APP-GW-GLE-016 NS

“Impact of In-core Instrumentation Grid, Quicklocs and Changes to Integrated Head Package (IHP)”

TITLE: Impact of In-core Instrumentation Grid, Quicklocs and Changes to Integrated Head Package (IHP)

These changes are intended to be included in revision 17 of the DCD.

Figure 1 Reactor Internals Interface Arrangement

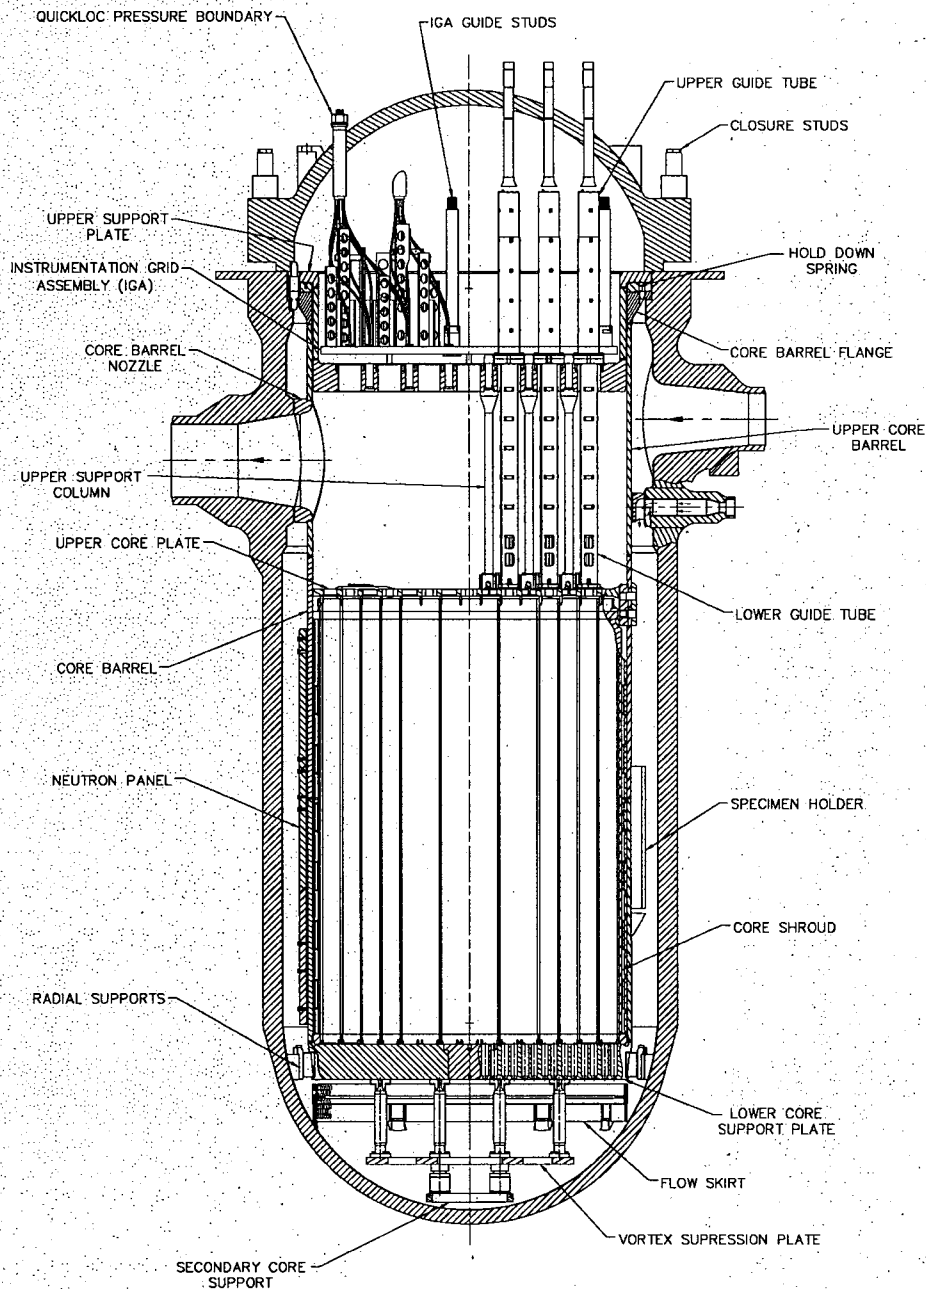
An instrument grid assembly is added to the reactor vessel upper internals package. This instrument grid assembly positions and supports the 42 instrumentation guide tubes. The IITAs fit inside the instrumentation guide tubes. They do not move from the instrumentation guide tubes until they have to be replaced. Six instrumentation guide tubes are ganged together to form an individual Quickloc stalk. The Quickloc stalks penetrate the reactor vessel head at eight Quickloc penetrations. A Quickloc is the primary coolant pressure boundary for up to six IITAs. This is shown in Figure 1 Reactor Vessel (DCD Figure 3.9-8 Reactor Internals Interface Arrangement).

Figure 2.1.3-3
Reactor Vessel Arrangement

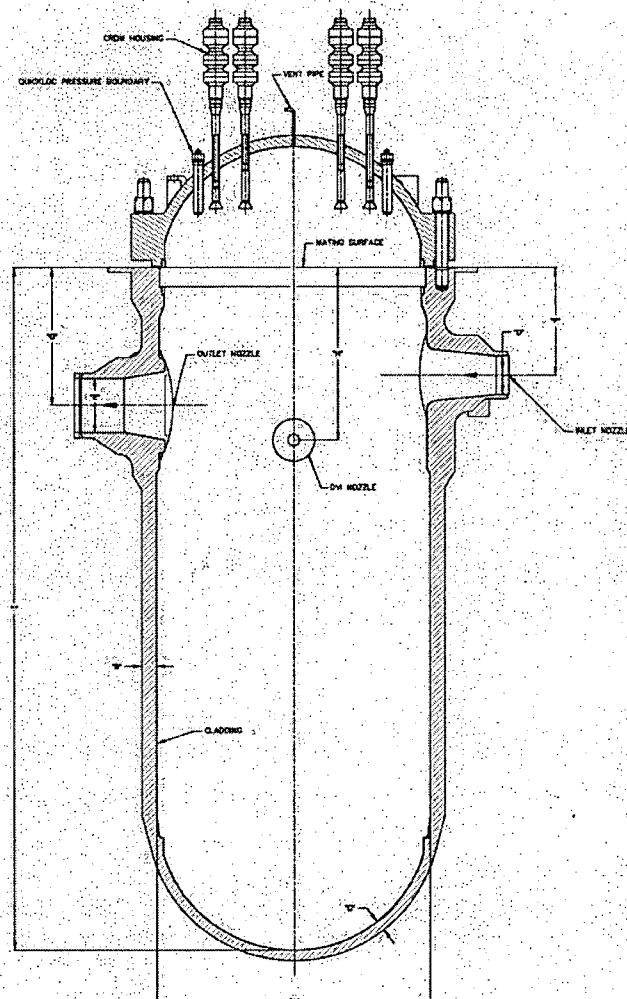
Components of the upper internals are being changed to allow the activated portion of the in-core instrumentation thimble tubes (IITAs) to remain underwater at all times during the refueling outage. This eliminates the 42 in-core instrumentation guide tubes penetration in the reactor vessel head and replaces them with eight Quickloc penetrations. The IHP storage stand and water tank are replaced with a conventional reactor vessel headstand. These changes will enhance safety; facilitate reactor vessel head inspection and lower Occupational Radiation Exposure (ORE) during refueling outages. Because the activated portion of the IITAs are kept underwater, the shielding on the IHP can be significantly reduced and the IITA thimble handling rig eliminated. This reduces the size and weight of the IHP lifting rig. It also allows the four CRDM cooling fans to be directly mounted to the IHP. This eliminates the removable CH-40 platform. The seven inch thick seismic support/shielding plate is replaced by a thinner plate. The seismic support function of this plate is replaced by a seismic support system used in the Westinghouse operating fleet. This system uses the Digital Rod Position Indicator Plates, which act as the lateral support for the CRDM via interaction with a grid work of spacer plates and a seismic support platform.

- Figure 2.1.3-3 Reactor Vessel Arrangement
- Figure 3.3-1 Nuclear Island Section A-A
- Figure 3.3-7 Nuclear Island Plan View at EL 117'-6"
- Figure 3.3-8 Nuclear Island Plan View at EL 135'-3"

Figure 3.9-6

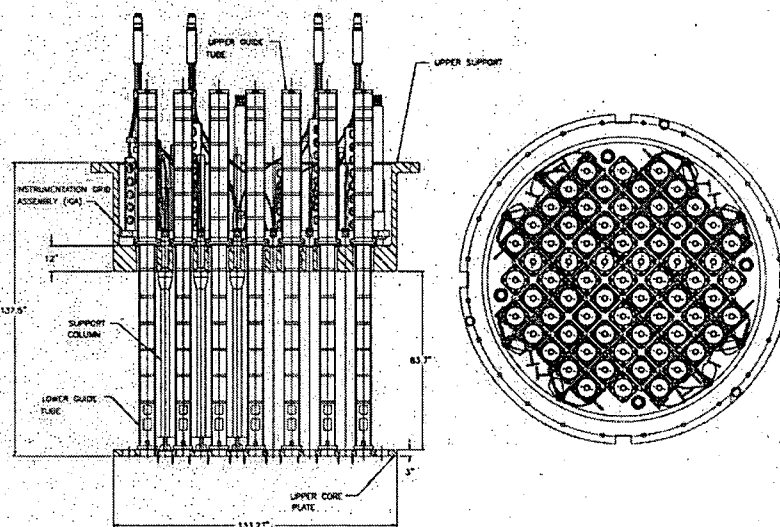
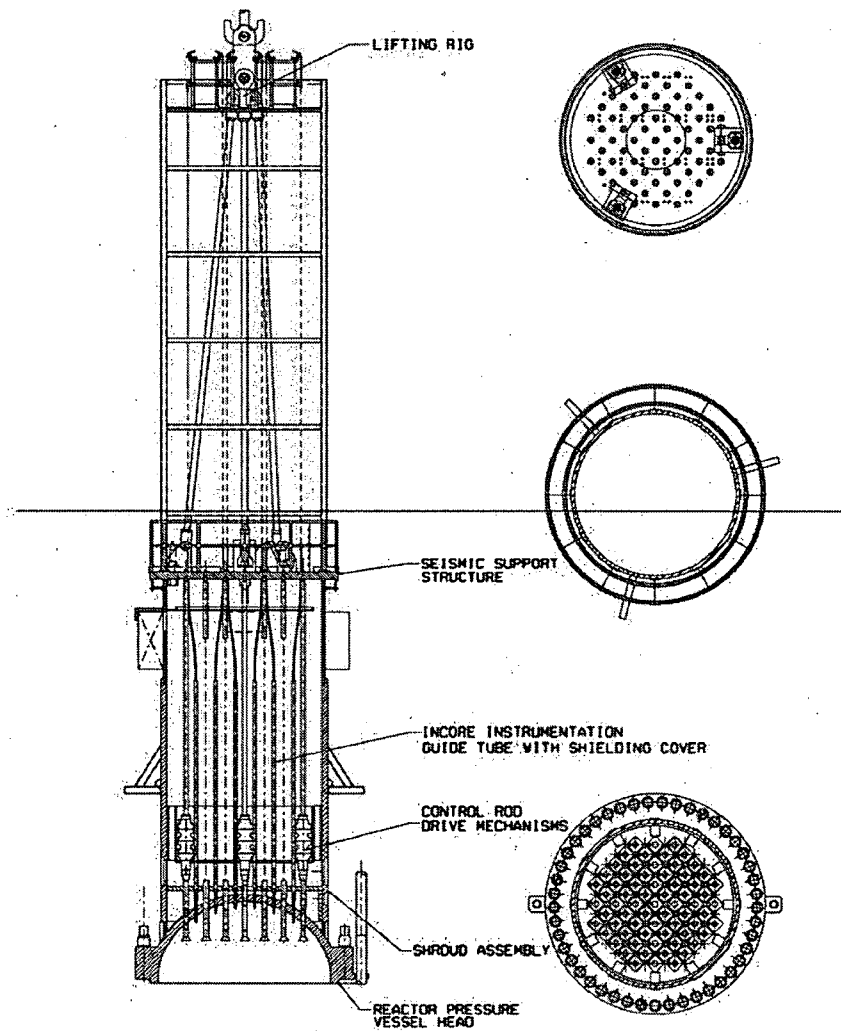
The AP1000 upper core support assembly consists of the upper support, the upper core plate, the support columns, and the guide tube assemblies. Figure 3.9-6 shows the upper core support assembly.

The support columns-grid assembly establish the spacing between the upper support and the upper core plate. The support columns are fastened at the top and bottom to these plates. The support columns transmit the mechanical loadings between the two plates and some serve the supplementary function of supporting the tubes that house the fixed in-core detectors. The instrument grid assembly housing the in-core detectors provide a protective path for the detectors during installation, reactor operation, and removal at refueling outages.

Figure 3.9-7

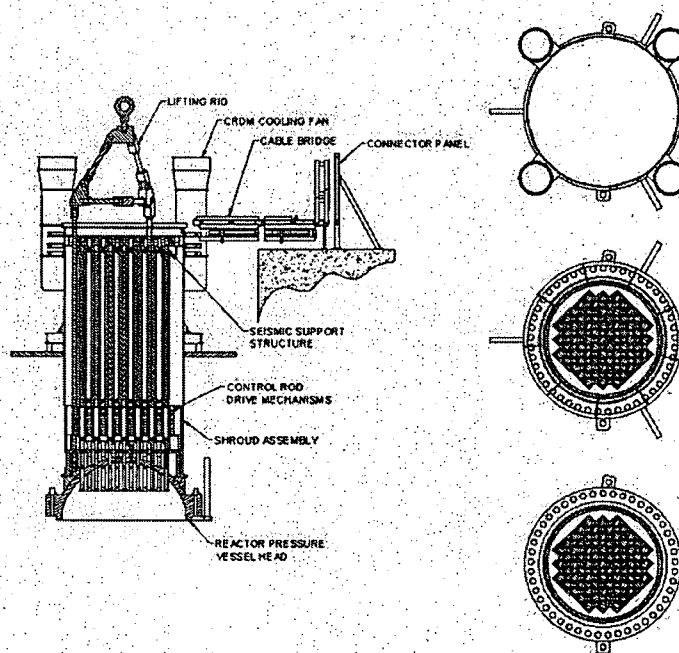
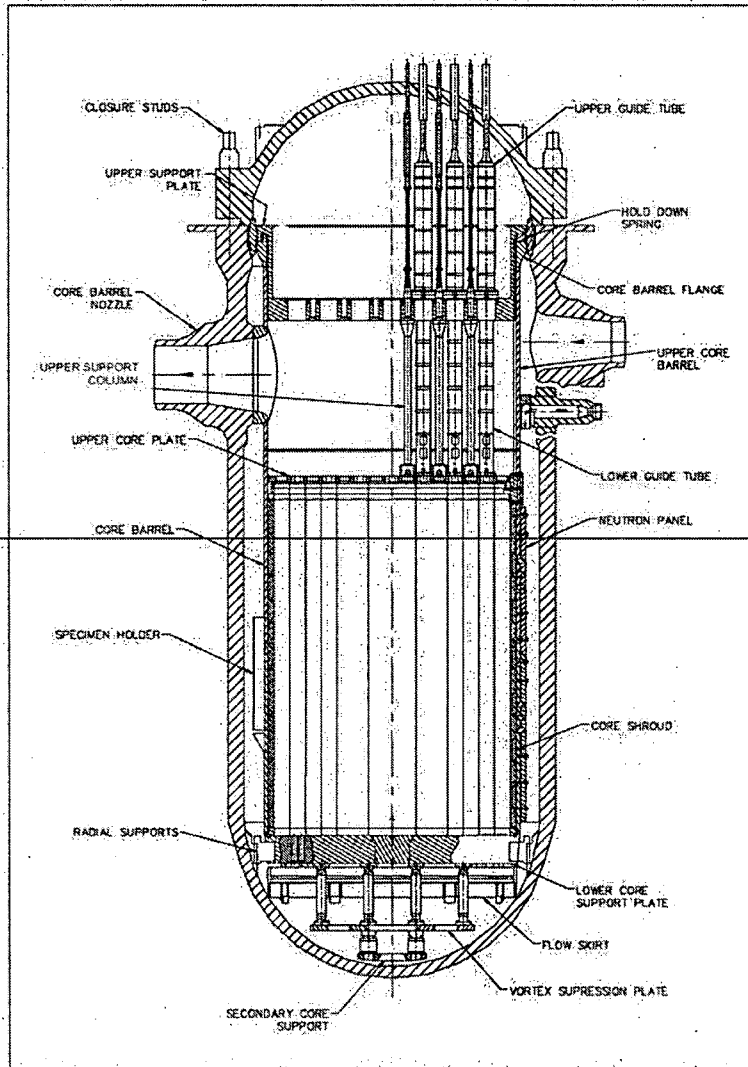
Since the activated portions of the IITAs are always underwater, the shielding of the IHP has been reduced. The IHP shroud still provides excellent shielding for the lower radioactive source term associated with the reactor vessel head and CRDMs within the IHP. The thimble rig is eliminated and the lower weight of the IHP allows for a smaller more compact lifting rig. Since the lifting rig is much smaller it remains on the IHP at all times during operation and refueling. The lower weight of the IHP allows the four CRDM cooling fans to be mounted directly on the IHP shroud structure. This eliminates the large plenums and ductwork as well as the CH-40 module that held the plenum, ductwork and four CRDM cooling fans.

The seven inch thick seismic support plate is replaced with a thinner plate. The seismic support function of this plate is replaced by a seismic support system of the type used in the Westinghouse operating fleet. This system uses the Digital Rod Position Indicator Plates, which act as the lateral support for the CRDM via interaction with a grid work of spacer plates and a seismic support platform.

The integrated head package (IHP) combines several components in one assembly to simplify refueling the reactor. Figure 3.9-7 illustrates the integrated head package. The integrated head package includes a lifting rig, seismic restraints for control rod drive mechanisms, support for reactor head vent piping, power cables, cables and guide tubes for in-core instrumentation, cable supports and shroud assembly.

Figure 5.3-1

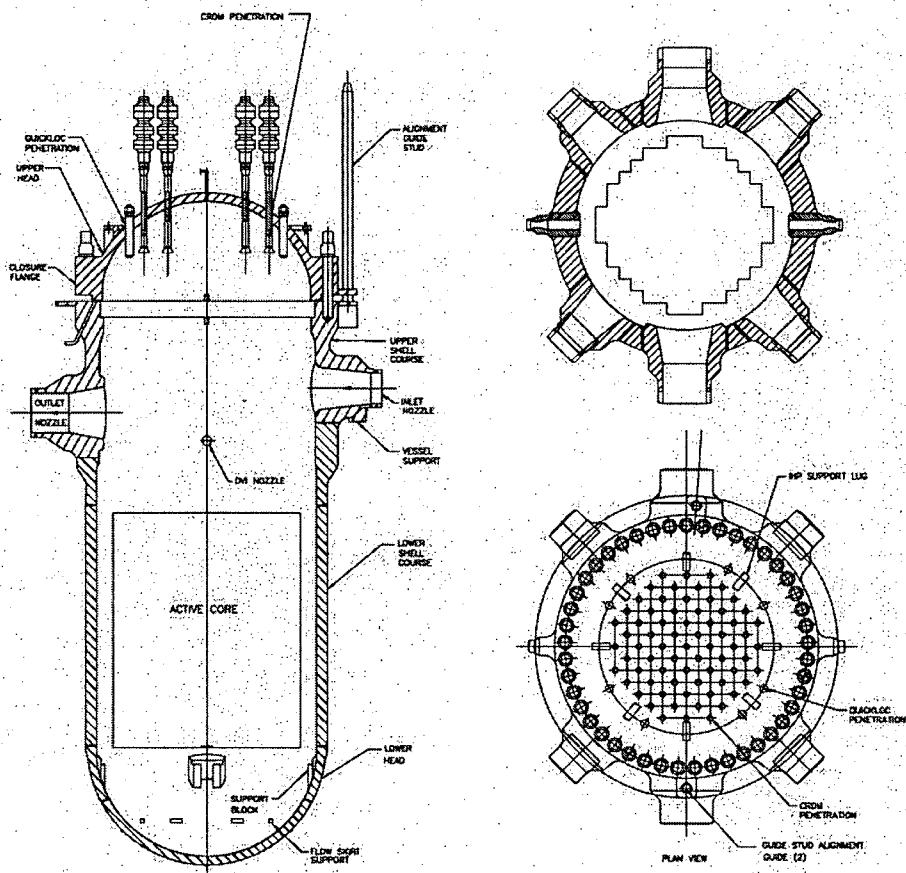
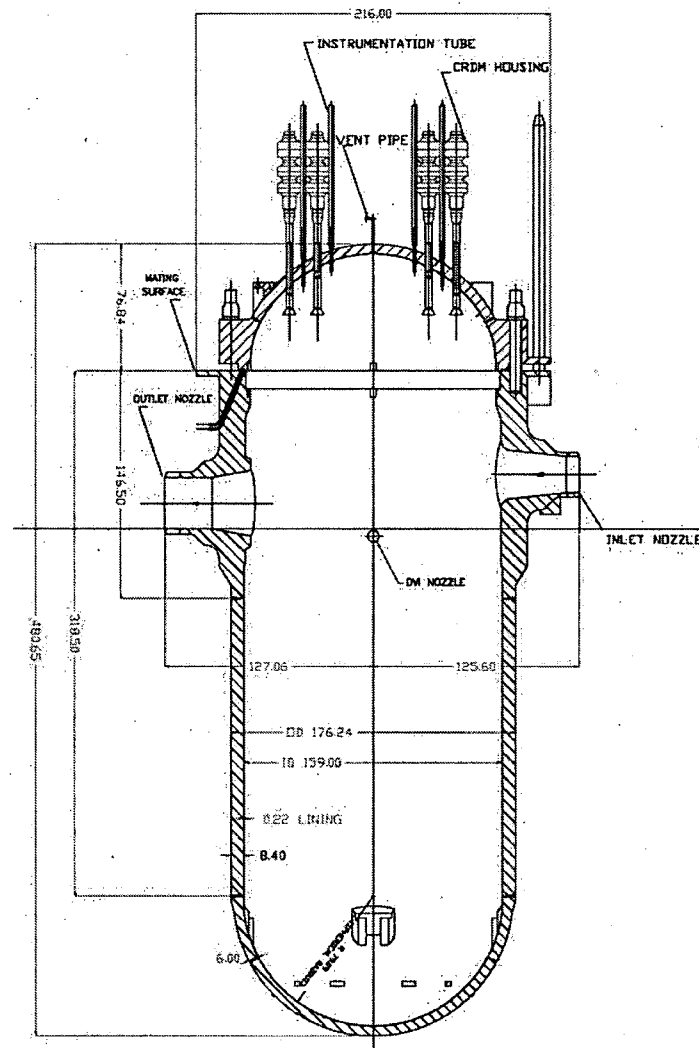
- Figure 5.3-1 Reactor Vessel
- Figure 5.3-6 Reactor Vessel Key Dimensions, Side View
- Figure 6.2.4-9 Hydrogen Igniter Locations Plan View Elevation 118'-6"
